Draft CO₂eq Calculation (JRC)**

Ricardo's initial conceptual thinking

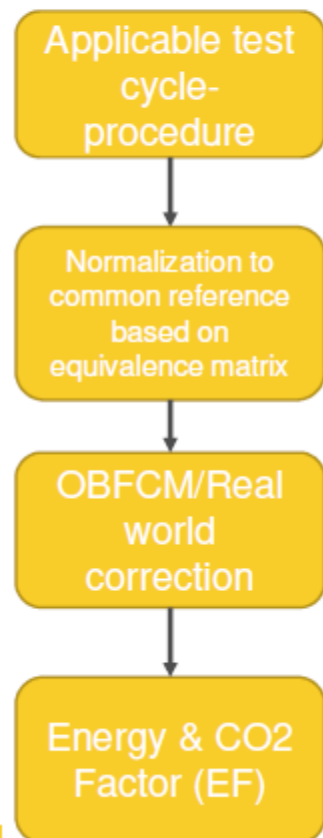
Not clear what arrows mean is this a sequence or change?

Might be related to energy consumption not km in some cases – e.g. H₂

Unclear why twice/two units – do you mean for operation on more than one energy type?
